MyGarage @ Northcrest PPR PCD No. PPR2412, AL234

Re: **MyGarage @ Northcrest: Traffic Memorandum
El Paso County, CO**

**DEVIATION REQUEST
AND DECISION FORM**

OVERALL SITE PLAN

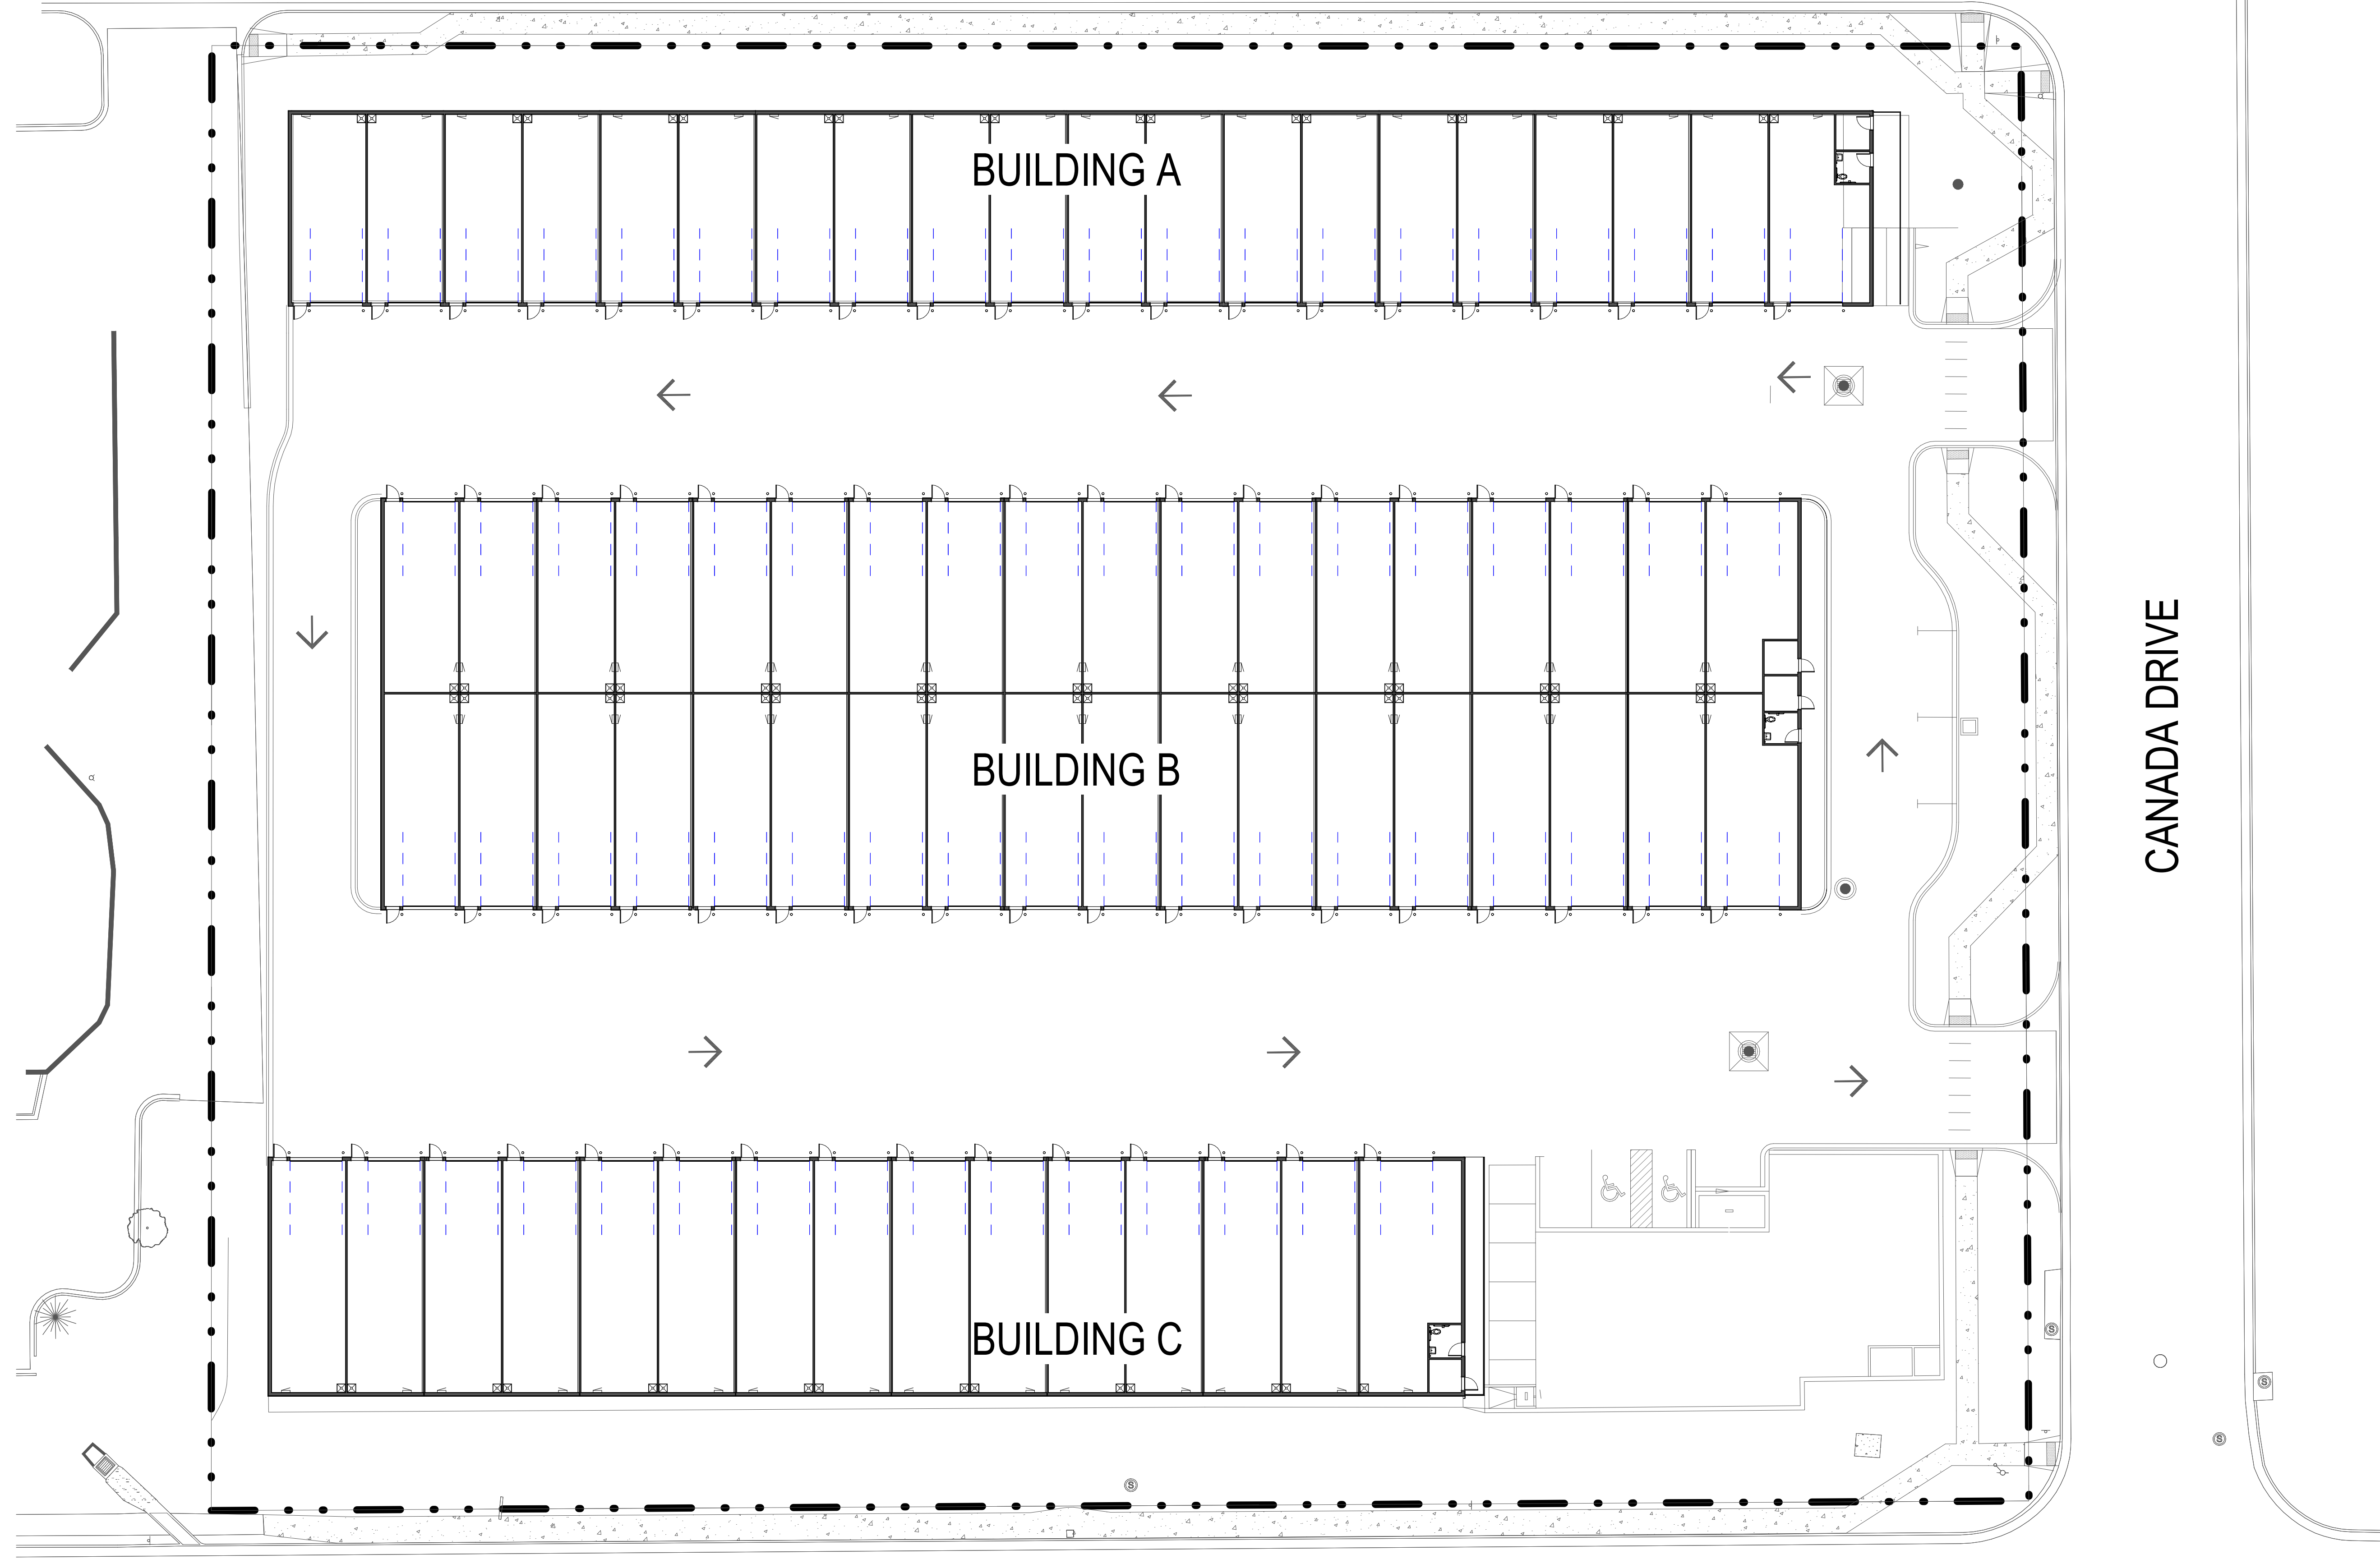
A deviation from the above is being requested for the southern and northern proposed accesses located along Canada Drive. The total site frontage along this roadway is less than 450'. It is necessary to the on site and neighboring property uses to maintain two accesses along the frontage. The two accesses have been designed to separate passenger vehicle and large truck traffic to facilitate safety. Passenger vehicles will primarily use the access to the south while larger single unit trucks would use the access to the north. Additionally, an easement is provided to the west of the site that shares access with a day care use. It is the intent of this design to minimize the necessity of any and all traffic in the proximity of the day care use.

Southern Access: The southern access, which is intended for passenger vehicles and the pedestrian accesses to the building, is proposed to be right-in/right-out along Canada Drive and connecting to the existing shared access off of Bismark Road to the west. The southern access is intended to only be used by passenger vehicles and pickup trucks. According to Section 2.4.1B Table 2-35 the Entering Sight Distance for Driveways for a 25 mph road and a single unit truck is 325'. A measure of sight distance for this entrance shows approximately 140' to Constitution Avenue. This represents a reduction from the standard of 185'. As the entrance is proposed right-in/right-out no conflicts exist with traffic coming from Constitution Avenue so no safety concerns are anticipated.

Northern Access: The northern access, which is intended for the loading traffic, is proposed as full movement along Canada Drive and connecting to the shared access off of Bismark Road to the west. The northern access is intended to be used by pickup trucks and single unit trucks. It is not anticipated that any multi unit trucks would use this access. As such and according to Section 2.4.1B Table 2-35 the Entering Sight Distance for Driveways for a 25 mph road and a passenger car vehicle is 325'. A measure of sight distance for this entrance shows approximately 255' to Constitution Avenue. As measured from Centerline to Centerline approximately 140' spacing between the southern and northern access is proposed.

Approved with the following conditions:
Southern access entrance along Canada Drive to be right in/right out only and have a sign(s) posted according to MUCTD limiting turns and vehicle size.
